KITCHEN EQUIPMENT AT VARIOUS SITES, PHASE II

Addendum # 2

Re: Hale High School

Drawing Addendum Number 2 - FS1.1.2.

SHEET NUMBER FS1.1.2

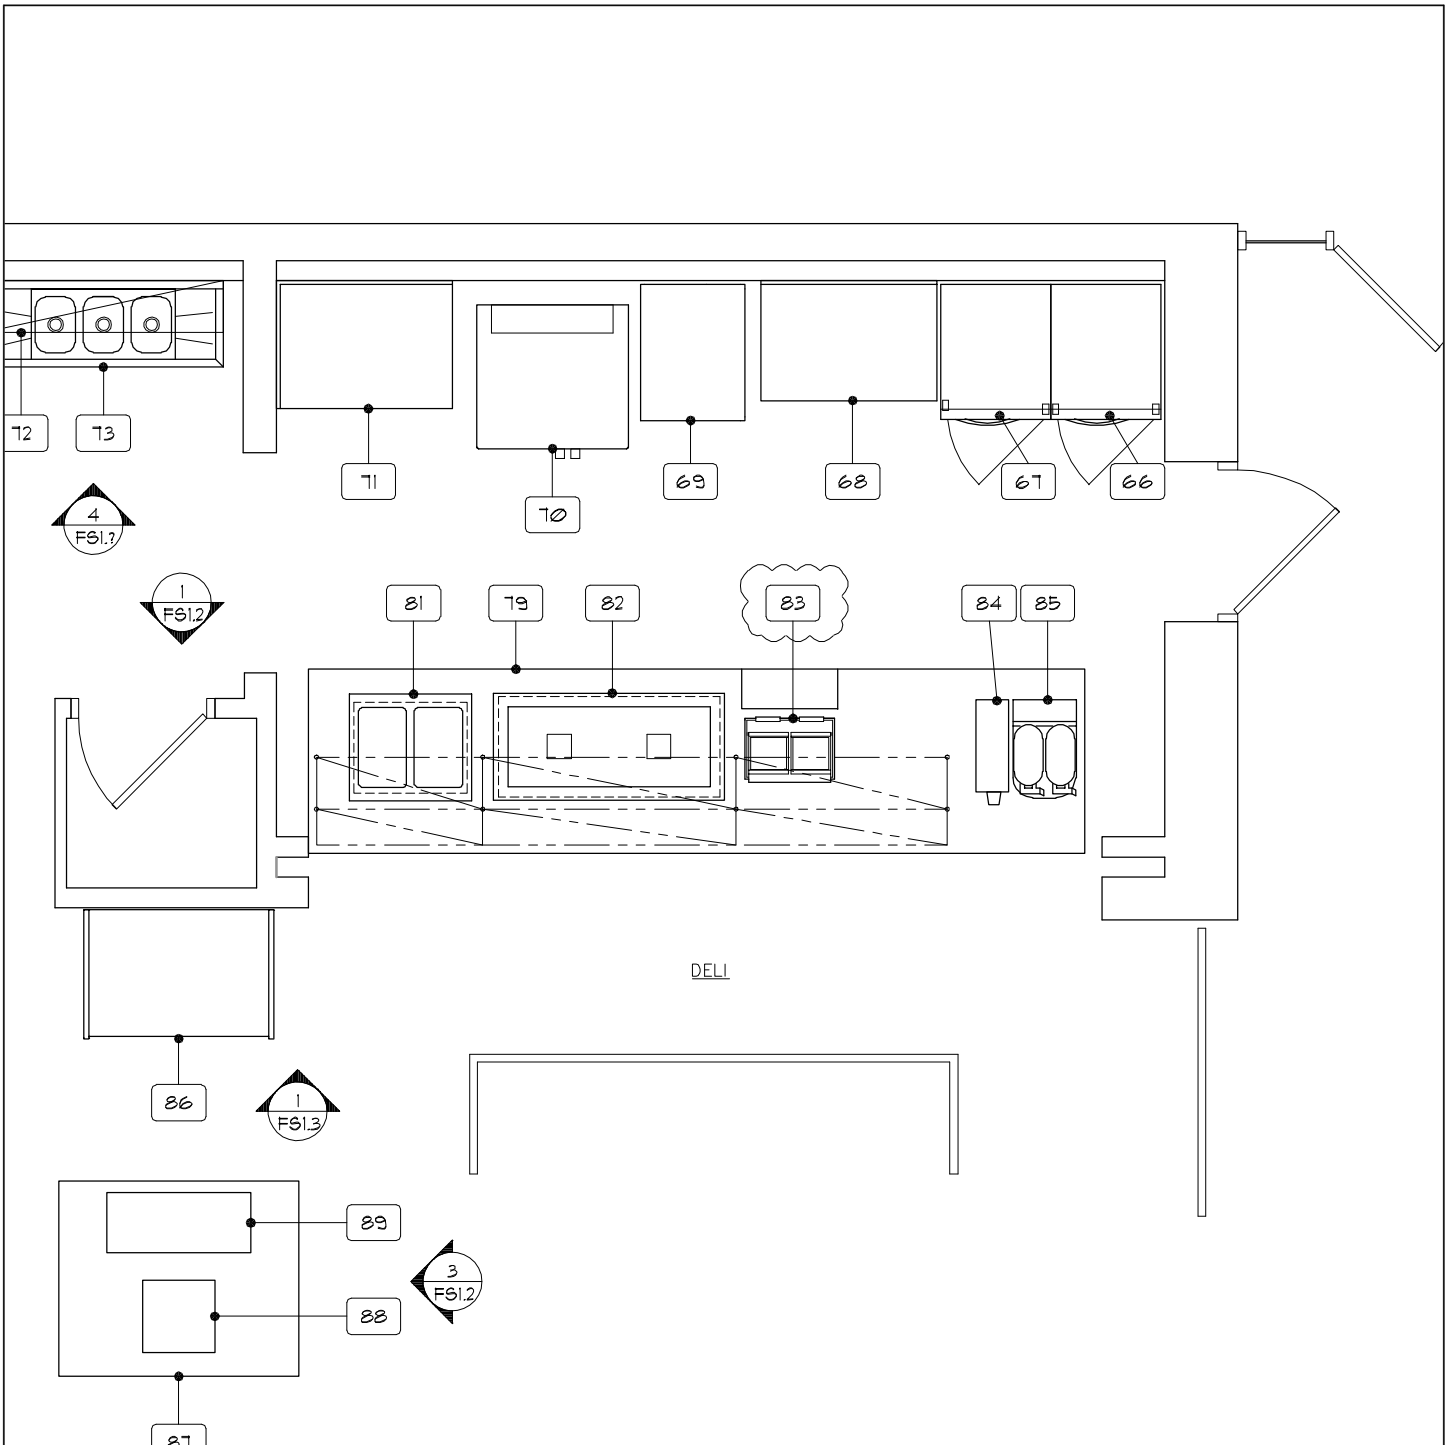
The panini grill number changed to 83.

The panini grill number changed to 83.
